CARLSON PARK

PRELIMINARY OVERALL AREA DEVELOPMENT PLAN
FILE NO. _____

Re: Carlson Park POADP # 672

REQUEST FOR REVIEW of POADP

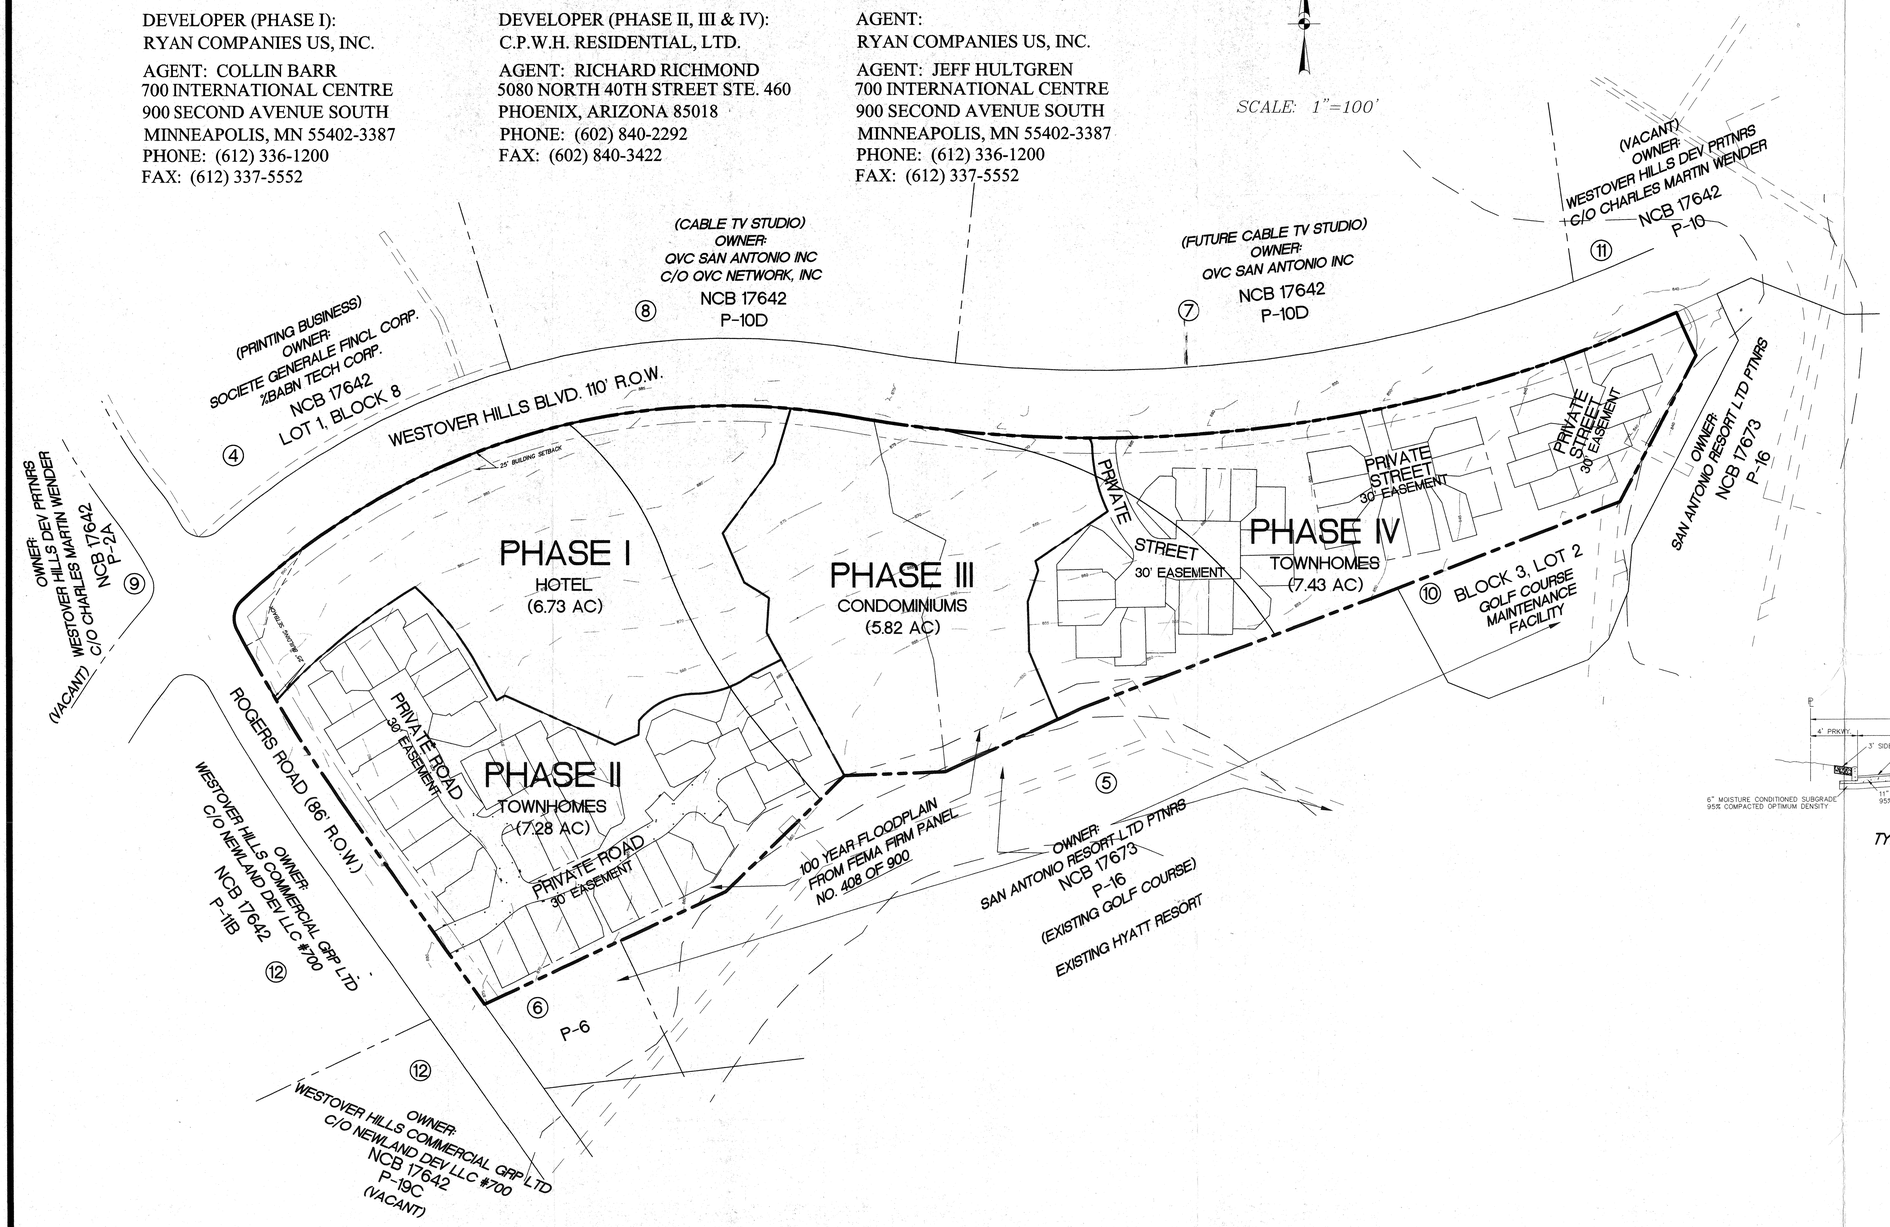
- Based on the topography, a Flood Plain Study and drainage review will probably be required during the platting process. Bexar County Public Works may require base flood elevations at the plat level.

- In consideration of public safety and convenience, excessive grades by reason of topography should be avoided in street layouts and arrangements.

- This development will probably need to conform to requirements associated with development over the Edwards Aquifer. For additional information about these requirements you can contact SAWS at 704-7305.

- Access and R.O.W. issues along State facilities will need to be resolved with the Texas Department of Transportation (TXDOT). For information about these requirements you can contact TXDOT at 615-5814.

- This development will need to comply with tree preservation ordinance #85262. For information about these requirements you can contact Building Inspections at 207-7102.

- It will be expected that you will plat all of the property depicted in your POADP, to include: floodpains, drainage areas and open space.

- I would encourage you to work closely with the school district, so that they can plan accordingly.

Comments: Westovercliff and Rogers Rd is on the MTP requiring ~~[illegible]~~ min. of 86' ROW.
